FINAL
DRAINAGE PLAN AND REPORT

A PROPOSED CHURCH AT 10695 LINDBERGH ROAD

SUBJECT: Final Drainage Plan and Report
Church at 10695 Lindbergh Road

DRAWN BY: D.E. WATTS		APPROVED BY:		REVISIONS		PROJECT		SHT. NAME		SHT. NO.	
DATE: 12-9-20		PROJ. NO.				16965 LINDBERGH ROAD		DRAINAGE PLAN		1	
DWG. NO.: 20-5449 01		DWG.				N1/2, N1/2, NW1/4, SE1/4, SEC. 22, T.11S., R.67W.				OF	
SURVEYED BY: DEV. ES. 4-29-20 12-4-20						EL PASO COUNTY				1

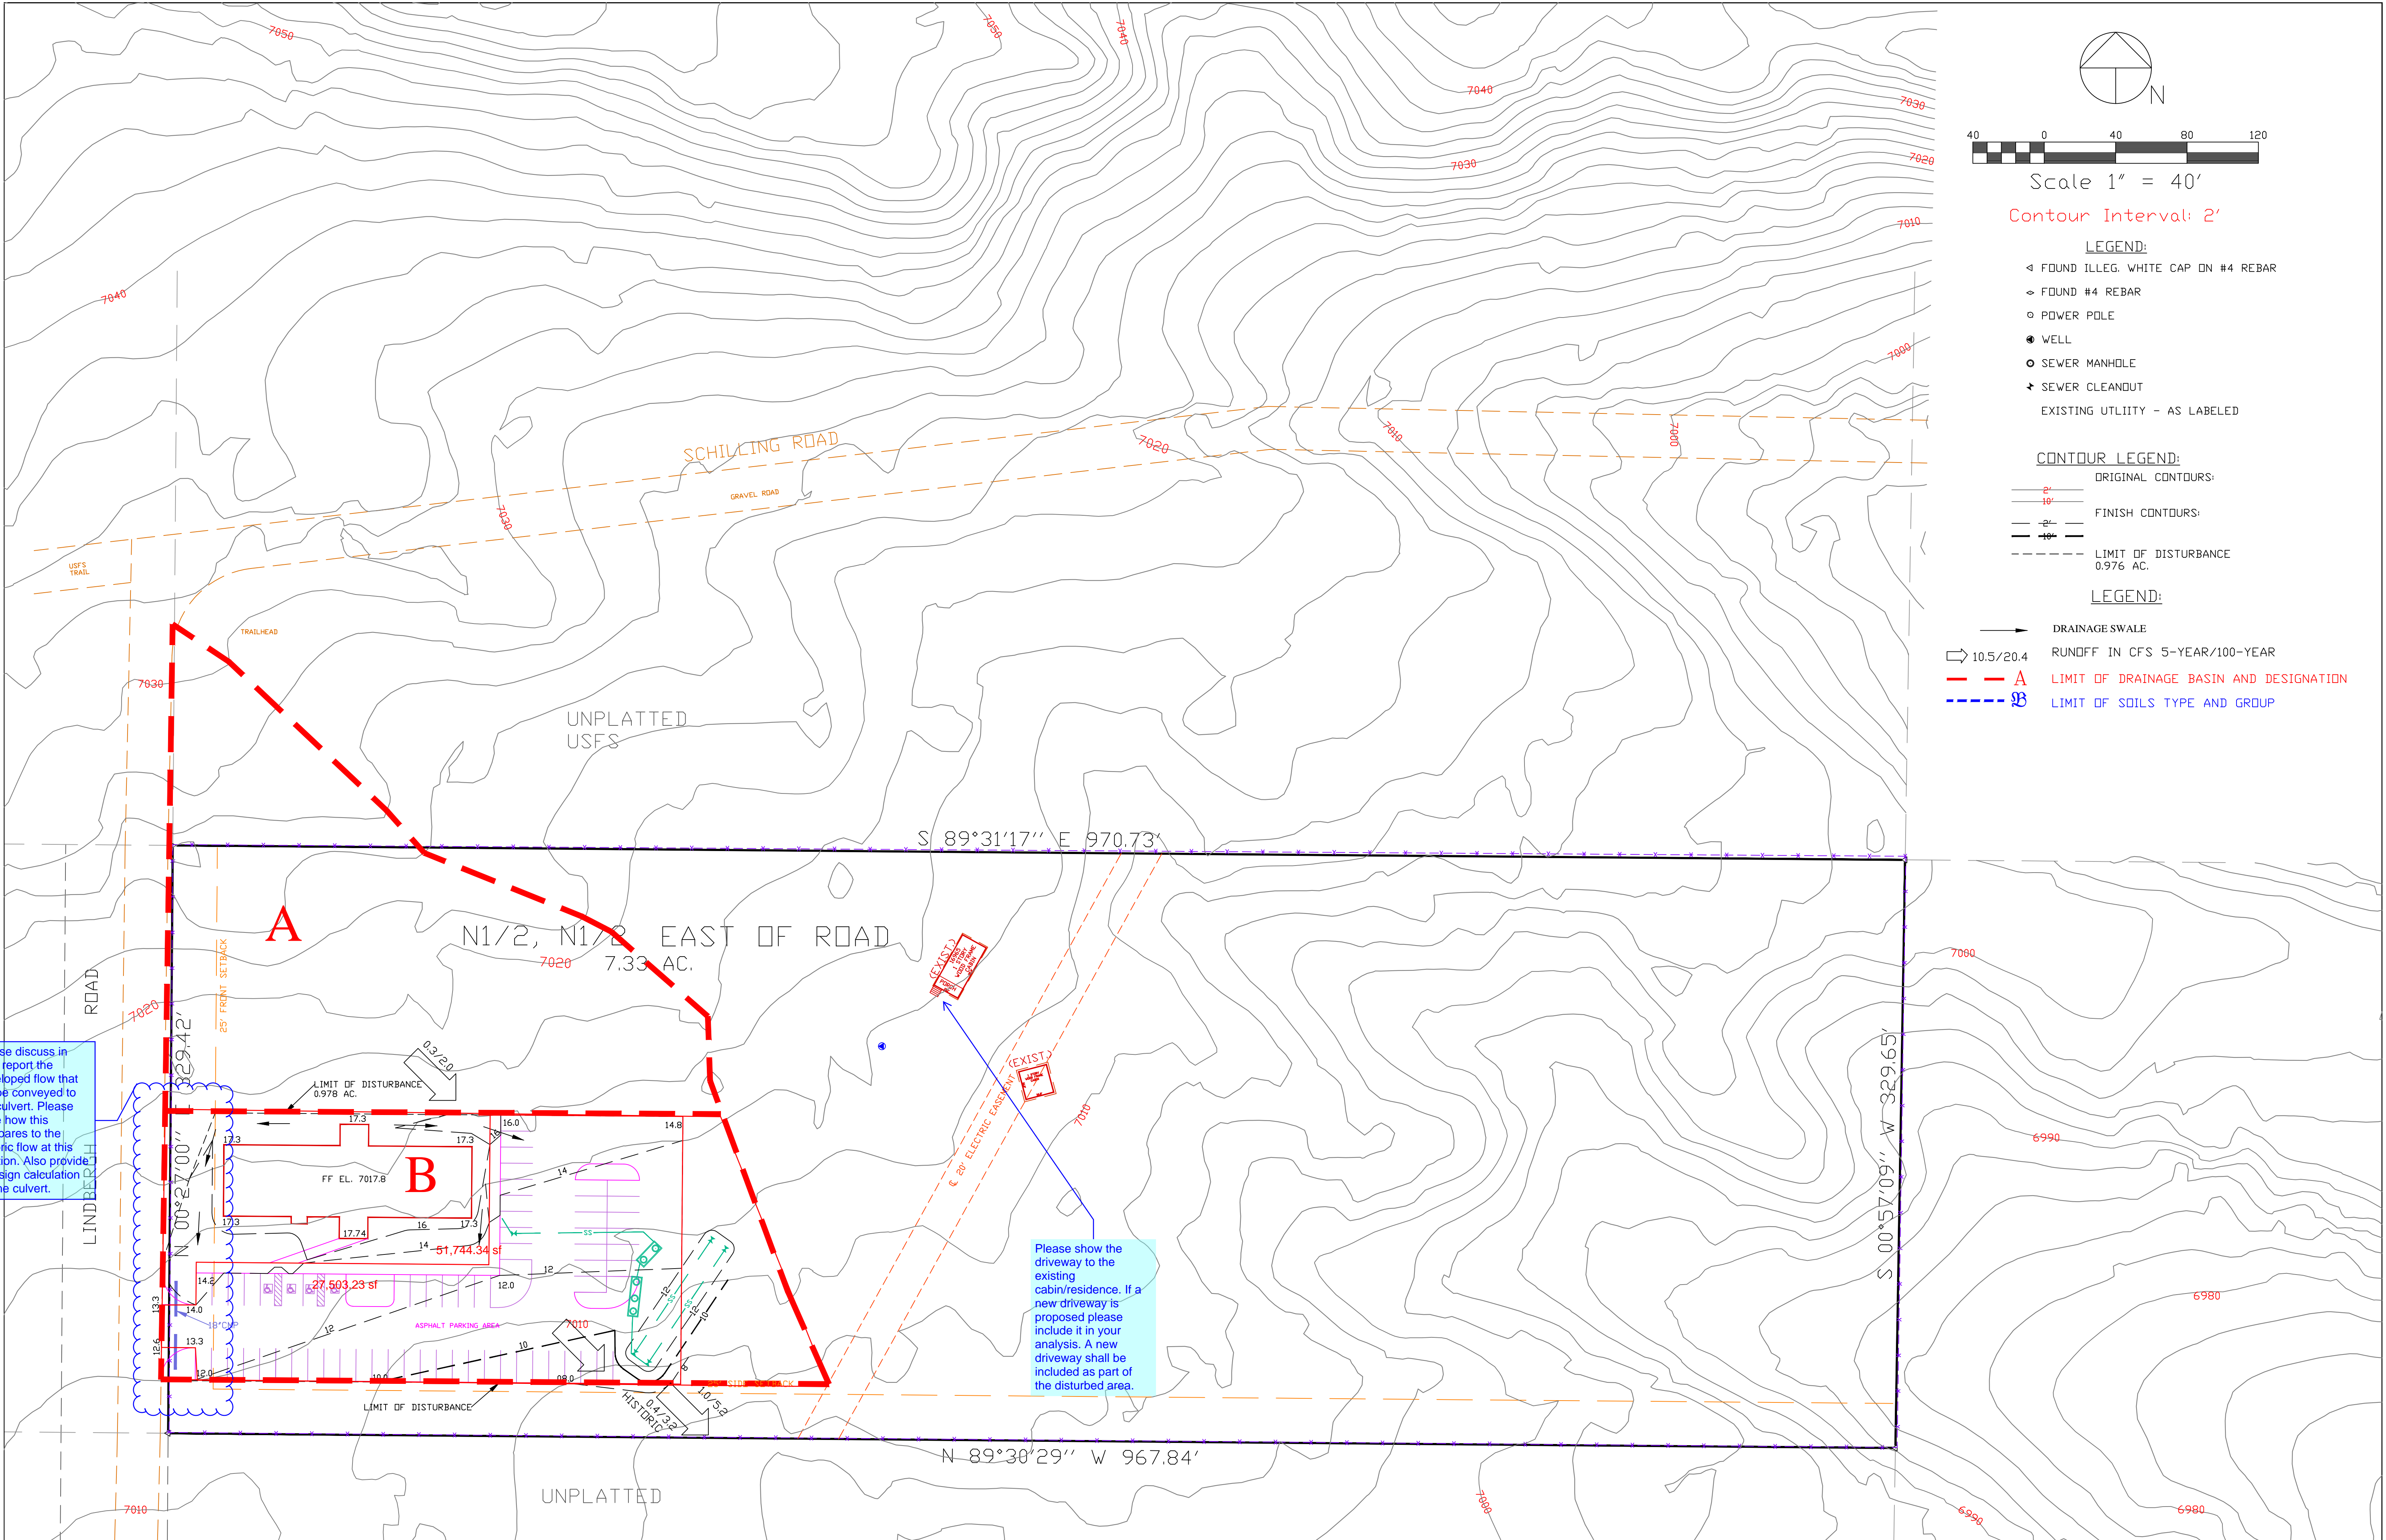
Please discuss in your report the developed flow that will be conveyed to the culvert. Please state how this compares to the historic flow at this location. Also provide a design calculation for the culvert.

Please show the driveway to the existing cabin/residence. If a new driveway is proposed please include it in your analysis. A new driveway shall be included as part of the disturbed area.

Please show the driveway to the existing cabin/residence. If a new driveway is proposed please include it in your analysis. A new driveway shall be included as part of the disturbed area.

Please discuss in your report the developed flow that will be conveyed to the culvert. Please state how this compares to the historic flow at this location. Also provide a design calculation for the culvert.
